## HISTORIC AND DESIGN REVIEW COMMISSION

October 21, 2020

**HDRC CASE NO:** 2020-455  
**ADDRESS:** 531 E CARSON  
**LEGAL DESCRIPTION:** NCB 993 BLK 3 LOT E 7.8 OF S 150 OF 2 & W 47.2 OF S 150 OF 3 ARB 6B  
**ZONING:** R-6, H  
**CITY COUNCIL DIST.:** 2  
**DISTRICT:** Government Hill Historic District  
**APPLICANT:** John Balint/J. Crawford LLC  
**OWNER:** ACOSTA JUDGE A & DIANA R  
**TYPE OF WORK:** Window replacement, siding replacement  
**APPLICATION RECEIVED:** October 02, 2020  
**60-DAY REVIEW:** Not applicable due to City Council Emergency Orders  
**CASE MANAGER:** Huy Pham  
**REQUEST:**

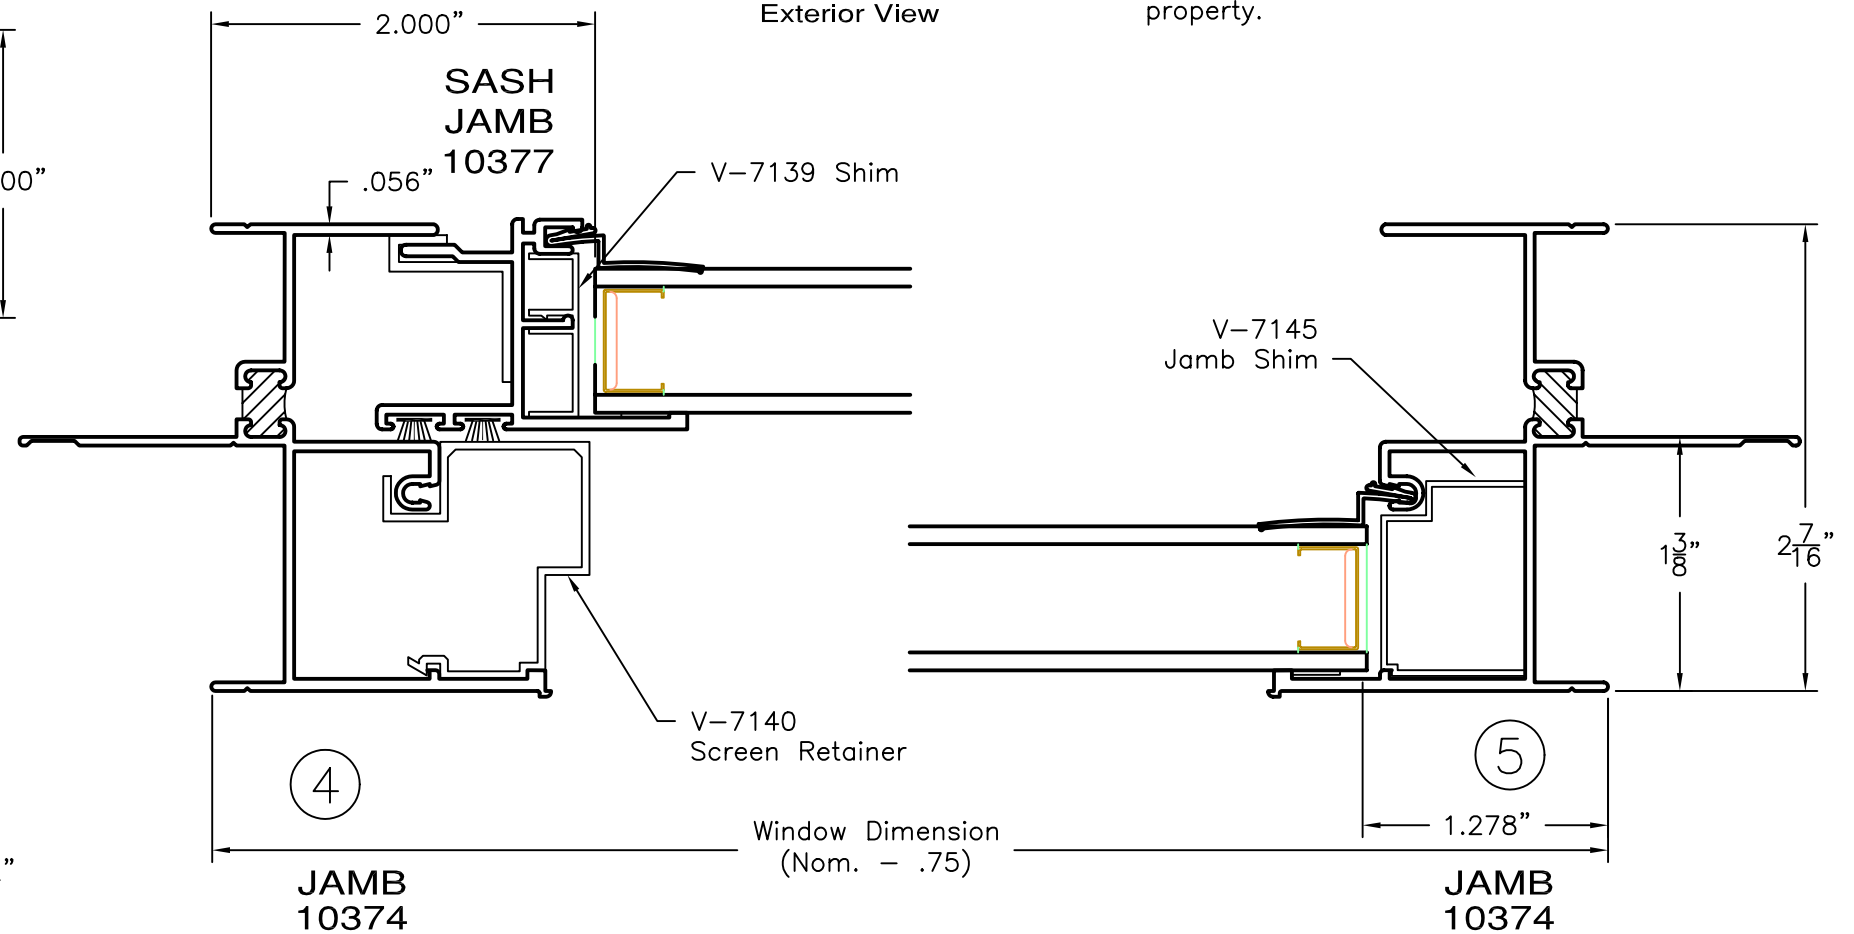
- b. WINDOW REPLACEMENT – The applicant has proposed to replace 15 non-original aluminum windows with new aluminum windows (PLYGEM 4810F). *Standard Specifications for Original Wood Window Replacement:* Where original windows are found to be missing or previously-replaced with a nonconforming window product by a previous owner, an alternative material to wood may be considered when the proposed replacement product is more consistent with the Historic Design Guidelines in terms of overall appearance; such determination shall be made on a case-by-case basis by OHP and/or the HDRC; and whole window systems should match the size of historic windows on property unless otherwise approved. Staff finds that the proposed window product is more consistent with the Historic Design Guidelines in terms of overall appearance. However, faux divided lites and nailing fin installations should still be avoided and original sizes and one-over-one sash configurations should be preserved.

- i. That the final window product must adhere to the Standard Specifications for Wood Window Replacement with the allowance of a non-wood product to replace a non-conforming window. Most notably, faux divided lites and nailing fin installations should be avoided and original sizes and one-over-one sash configurations should be preserved when utilizing PLYGEM 4810F (also referred to as Alenco Windows) or a similar window product that is submitted to staff prior to purchase and installation..
- ii. Siding replacement should be further reviewed after staff can assess the condition and profile of the exposed wood siding. Based on the already exposed portions, staff recommends that the structure should be restored to 117 profile instead of the proposed 105 profile.
